World Forum for Harmonization of Vehicle Regulations

Working Party on Passive Safety

Report of the Working Party on Passive Safety on its fifty-fourth session

Draft Amendment 2 to global technical regulation No. 9 (Pedestrian safety – Phase 2)

"(b) Neoprene sheets

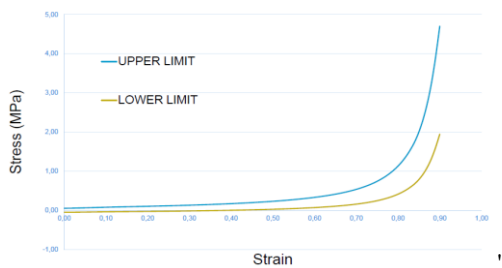
Figure 15(b), shall be deleted

Insert new Figure 15(b), to read:

Figure 8A

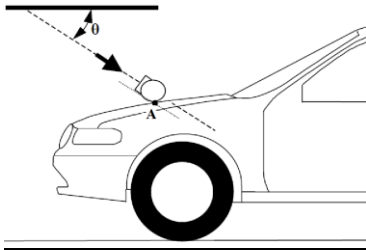
2.26.1. "Measuring point" for the headform test means a point on the vehicle's outer surface selected for assessment. The measuring point is where the headform's profile contacts the vehicle's outer surface cross section in a vertical longitudinal plane through the centre of gravity of the headform (see Figure 8A).

Measuring point in the vertical longitudinal plane through the center of the headform impactor (see paragraph 2.26.1.)²

"Figure 3
Example of marking of HIC1000 zone and HIC1700 zone

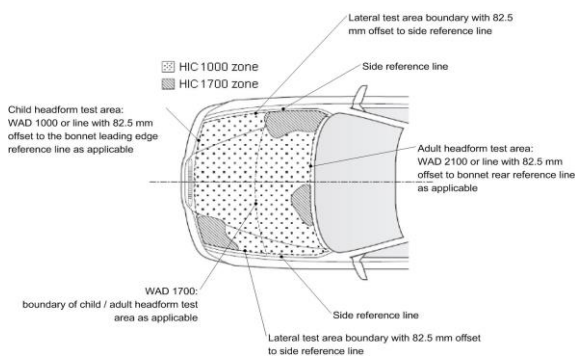
Annex 5, Figure 3, amend to read:
